Number: V2500-NAC-78-0192

SUBJECT: "MODIFICATION SERVICE BULLETIN" - "NACELLE - EXHAUST - THRUST
REVERSER COMPRESSION STRUT - ADDITION OF PROTECTIVE SLEEVE"

(1) Airplane: MD-90

Thrust Reverser Compression Strut Protective Sleeve
Figure 1 (sheet 1)

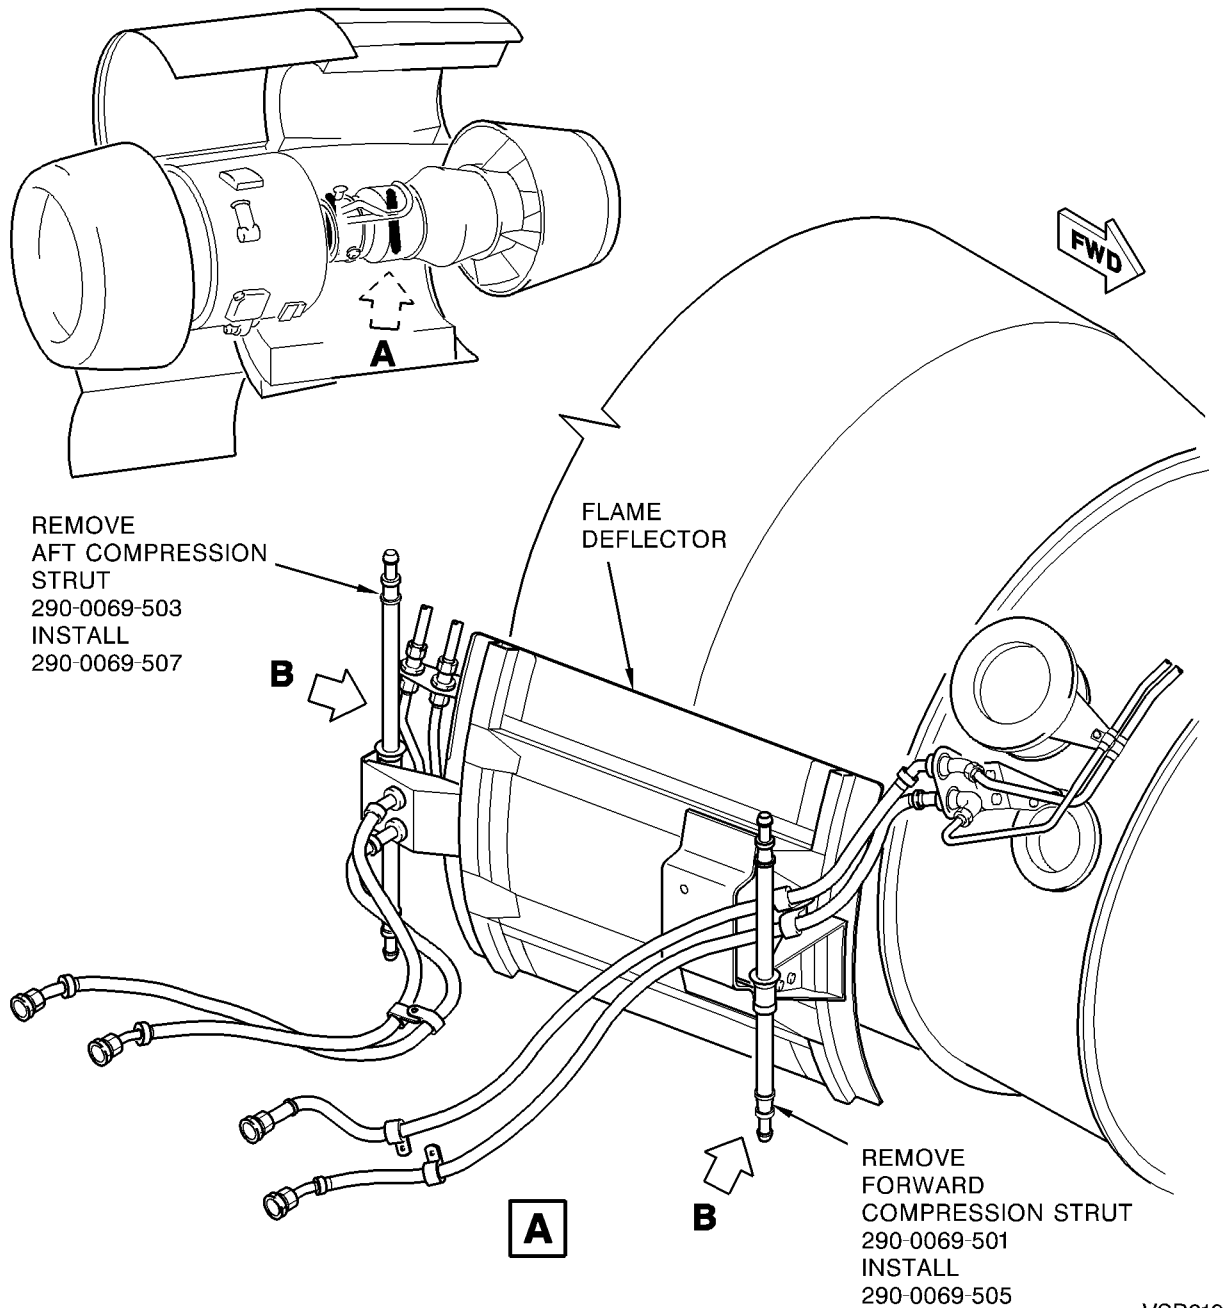
- A. For compression struts that are installed, open the thrust reverser halves. Refer to the MD-90 Aircraft Maintenance Manual.
- B. For compression struts that are installed, remove the thrust reverser compression struts from the flame deflector. Refer to Figure 1.

- D. Install the protective teflon sleeve on the compression struts. Refer to the manufacturer's instructions. Refer to Figure 1.
- E. Re-identify the 290-0069-501 strut as the 290-0069-505. Re-identify the 290-0069-503 strut as the 290-0069-507. Use rubber stamp and metal marking ink. Refer to the IAE V2500 Standard Practices/Processes Manual (SPP-V2500-1AE), Chapter 70-09-00.

- F. Install the thrust reverser compression struts on the flame deflector. Make sure the "UP" mark on the compression strut is at the upper end of the strut. Refer to Figure 1.

- (1) Install the 290-0069-505 (short) compression strut at the forward end of the flame deflector.
 - (2) Install the 290-0069-507 (long) compression strut at the aft end of the flame deflector.
